**FINAL ENVIRONMENTAL IMPACT STATEMENT FOR
HYDROPOWER LICENSES**

BIG CREEK ALP PROJECTS

Docket Nos. P-67, 2175, 2085, and 120

Figure 2-1. Existing facilities in the Big Creek System. (Source: FERC, 2002)

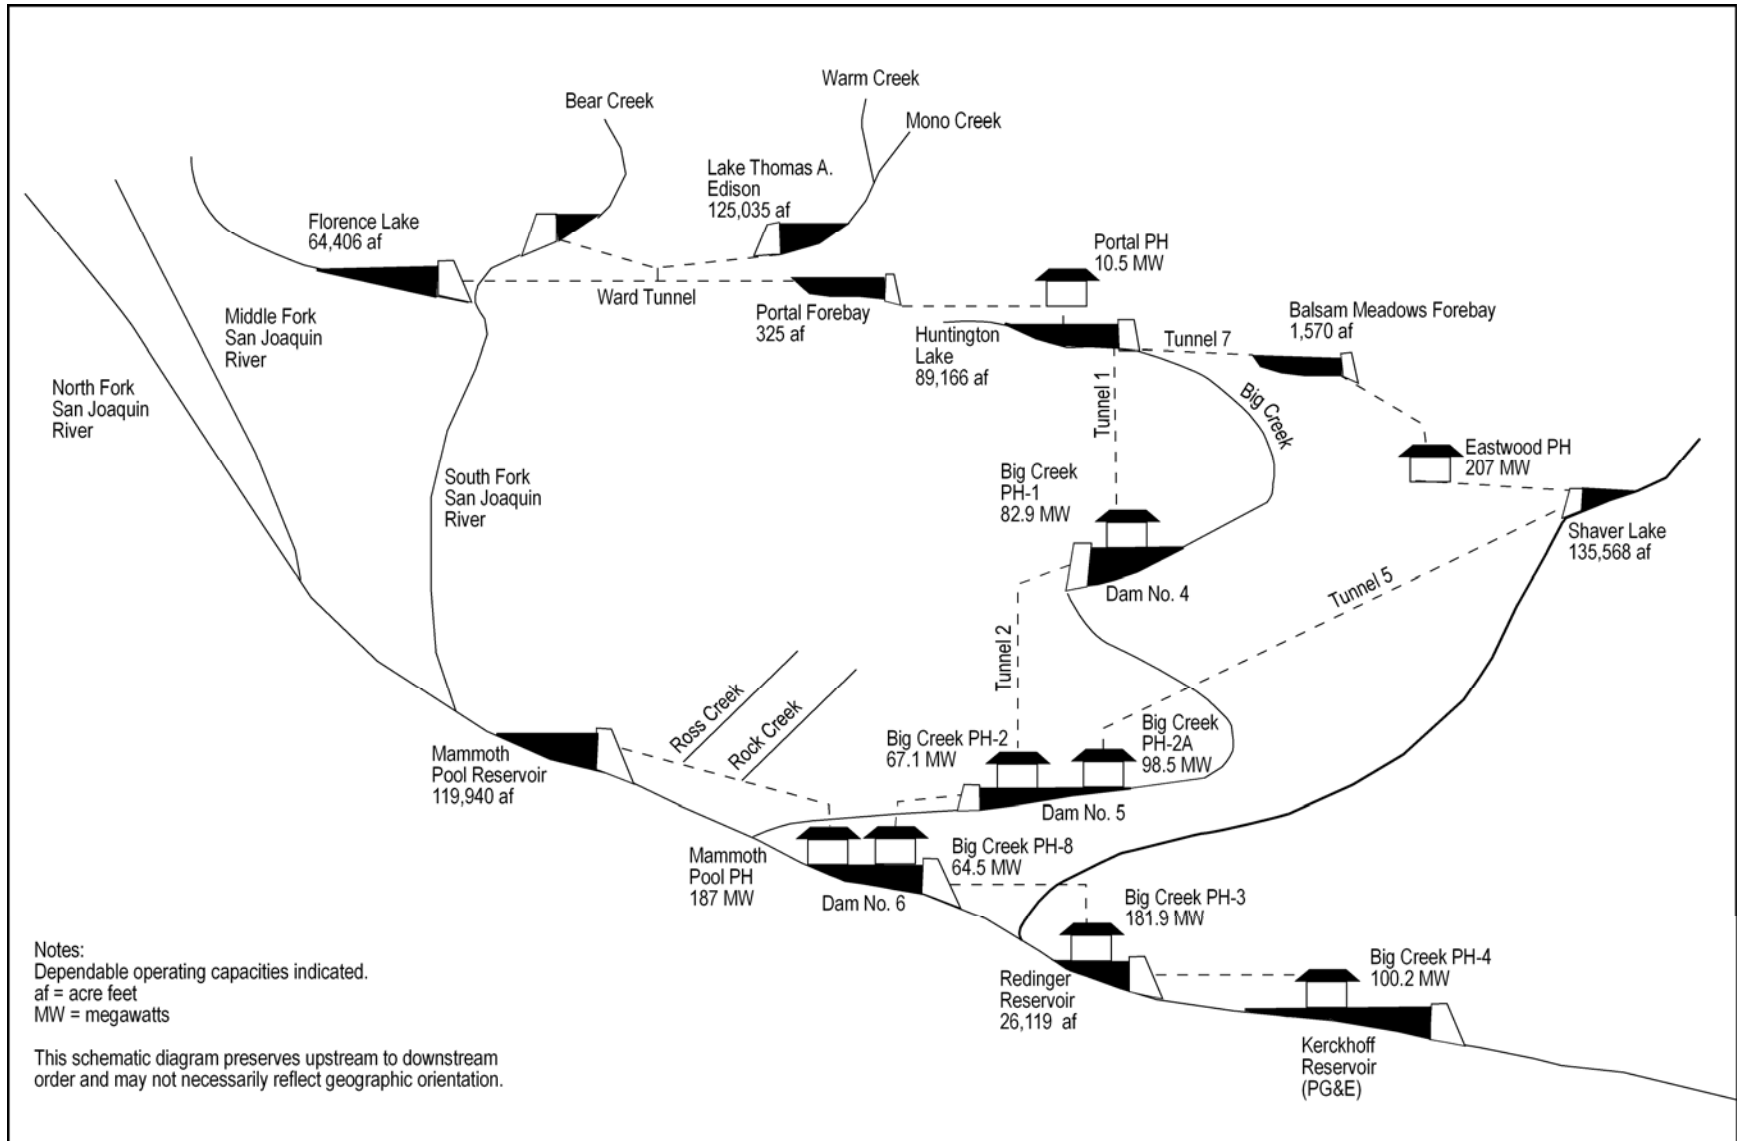
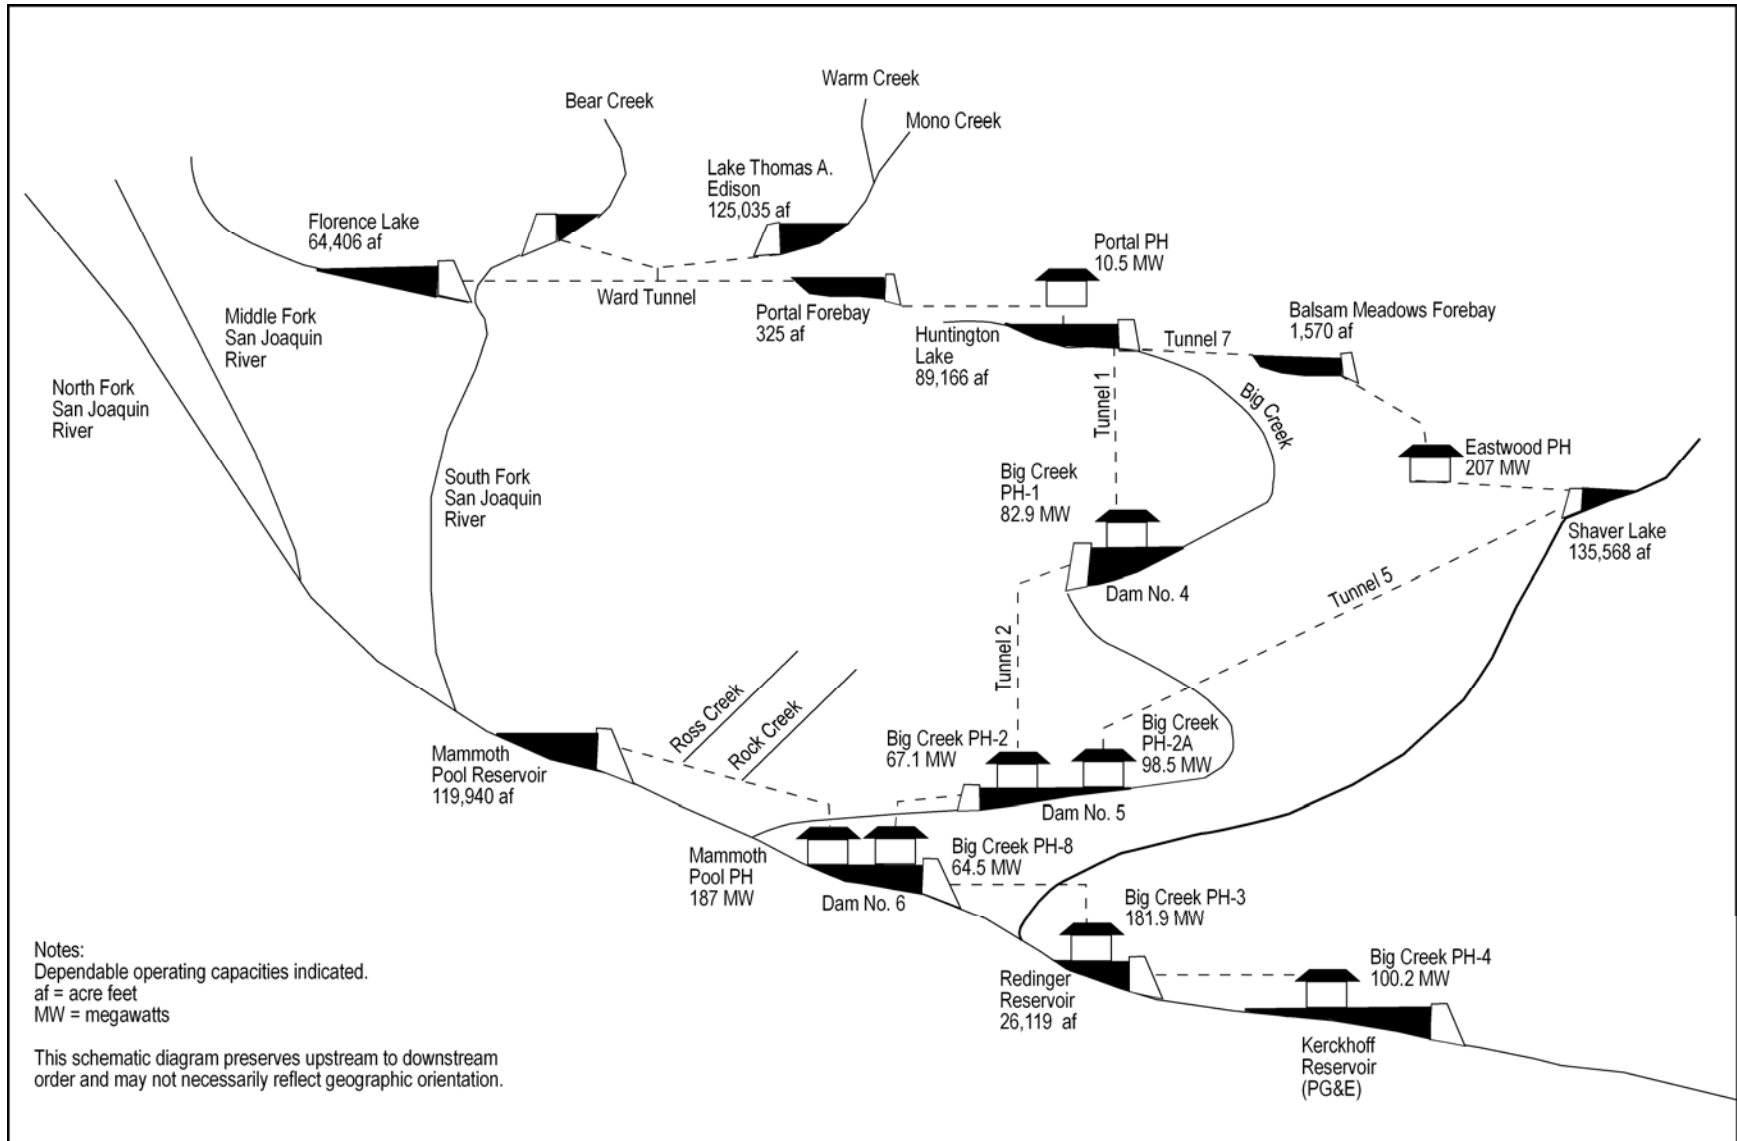
Comment 13: SCE recommends modifying the dependable operating capacity values shown in figure 2-1 as follows: (1) Big Creek powerhouse 2A should be 98.5 megawatts (MW); (2) Big Creek powerhouse 1 should be 82.9 MW; (3) Mammoth Pool powerhouse should be 187 MW; and (4) Big Creek powerhouse 3 should be 181.9 MW. In addition, Florence Lake usable storage is 64,406 acre-feet.

Comment 14: The Forest Service notes that the schematic shown in figure 2-1 (page 2-3 of the draft EIS) does not indicate that Balsam Creek releases from the forebay are recaptured downstream within the Big Creek System.

Response: We have adjusted figure 2-1 to more accurately reflect the description of various project features.

Response: The purpose of figure 2-1 is to show the geographical relationship of existing project facilities associated with the Big Creek System, not the flow through the system. The complex nature of flows through the Big Creek System, including the fate of water released to Balsam Creek from the Balsam Meadows forebay, is shown in figures 3-1 (page 3-5 of the draft EIS) and 3-6 (page 3-46 of the draft EIS).
